**42 HAMPSTEAD LANE
LONDON, N6 4LL**

NMA APPLICATION I
NOVEMBER 2023

SUMMARY OF CHANGES

CONSENTED VS NMA i PROPOSALS

PROPOSED LOWER GROUND FLOOR

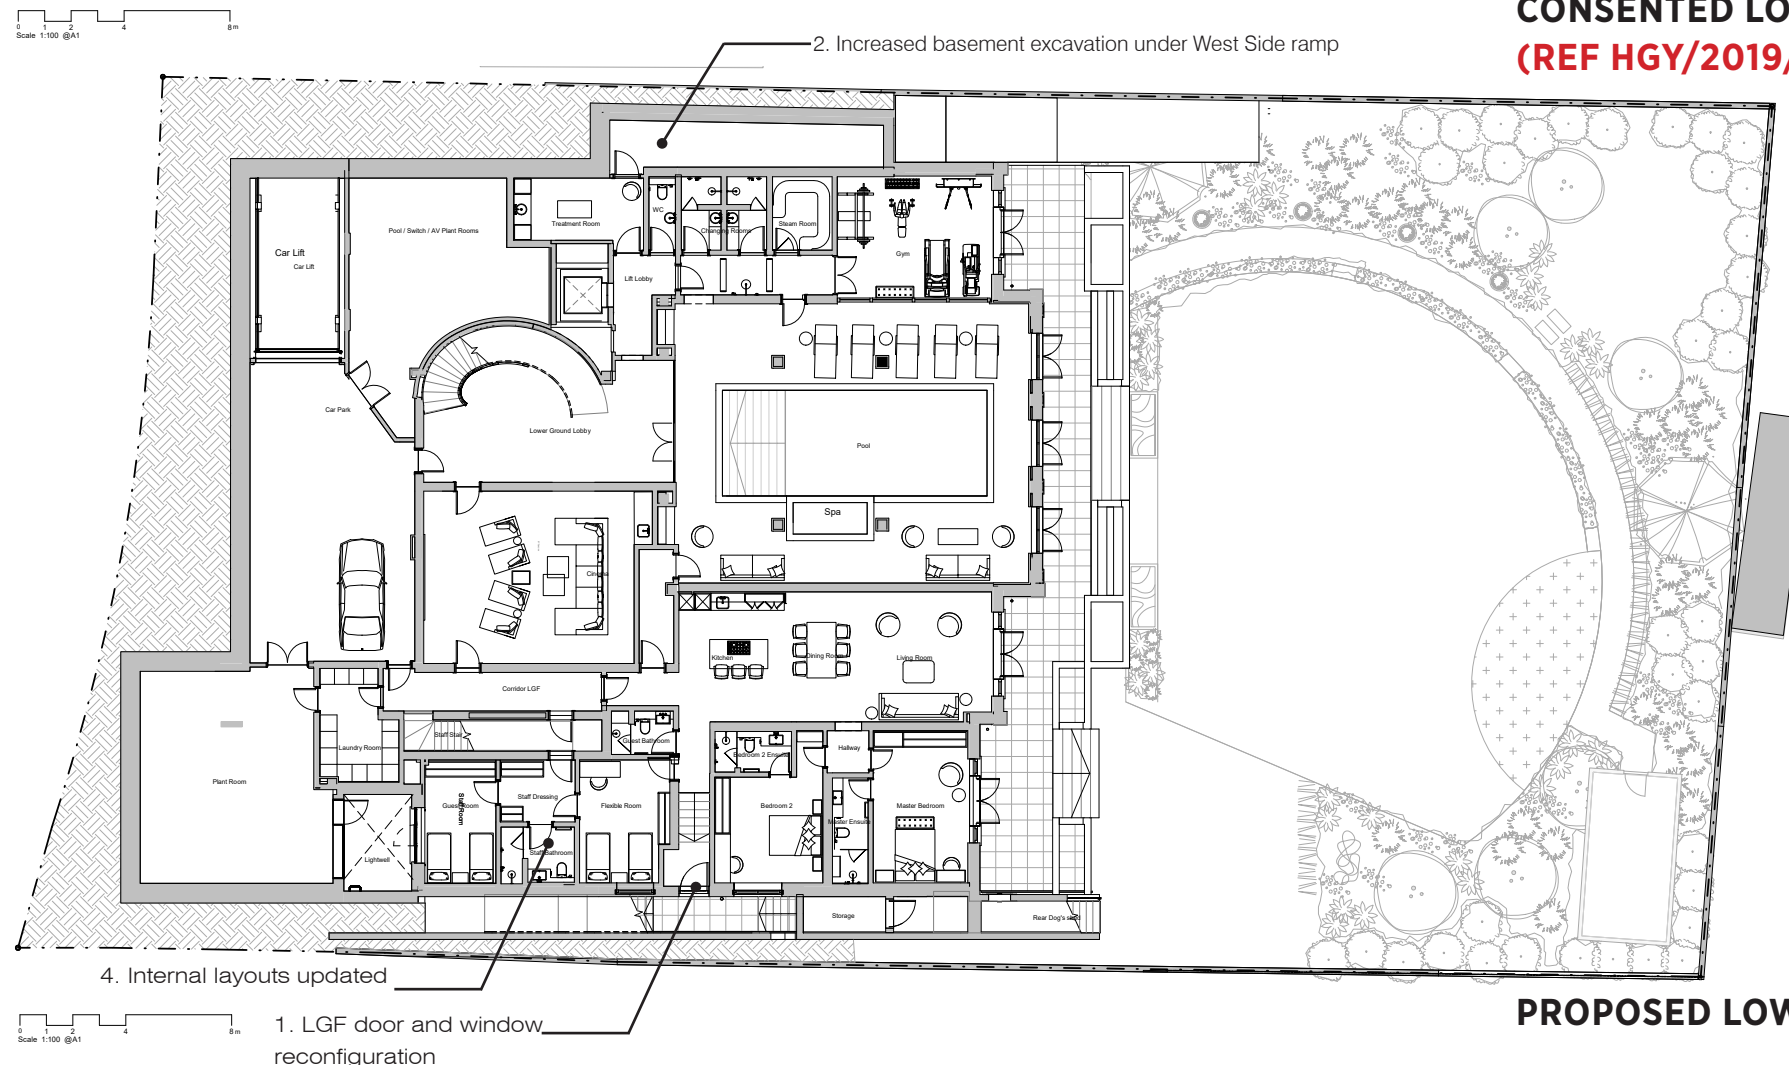
1. LGF door and window reconfiguration.
2. Increased basement excavation under West Side ramp.
3. Rear external staircase reconfiguration.
4. Internal layout changes.

PROPOSED FIRST FLOOR

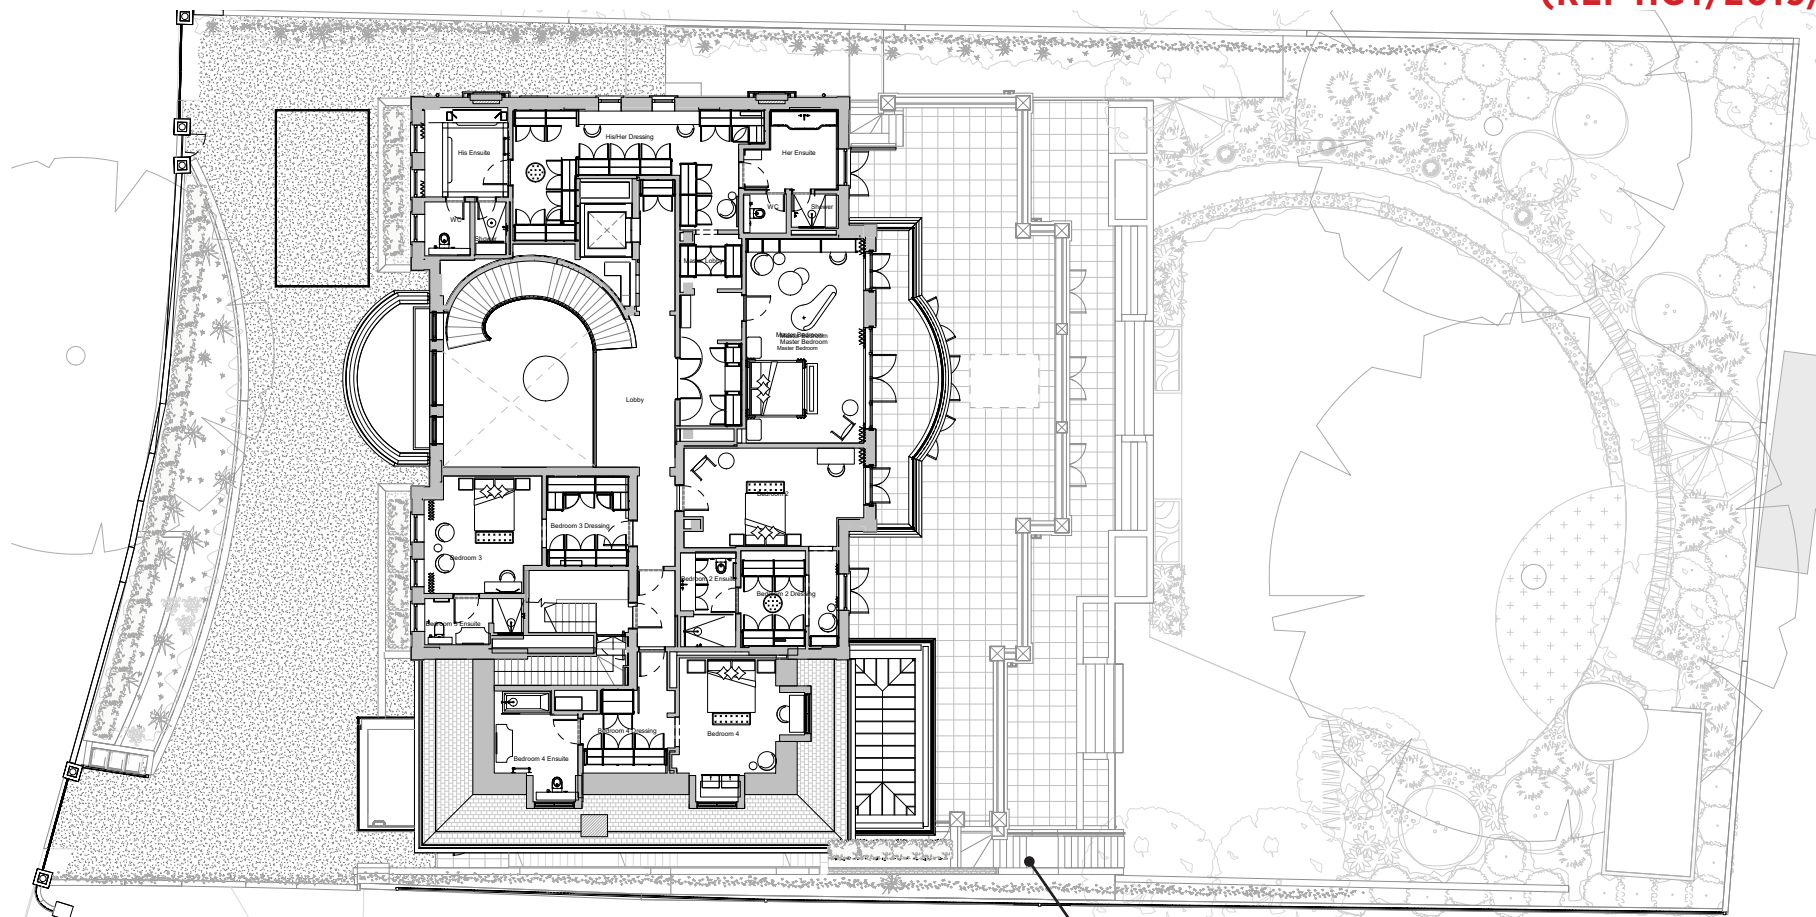
3. Rear external
staircase reconfiguration
(NMA 1)
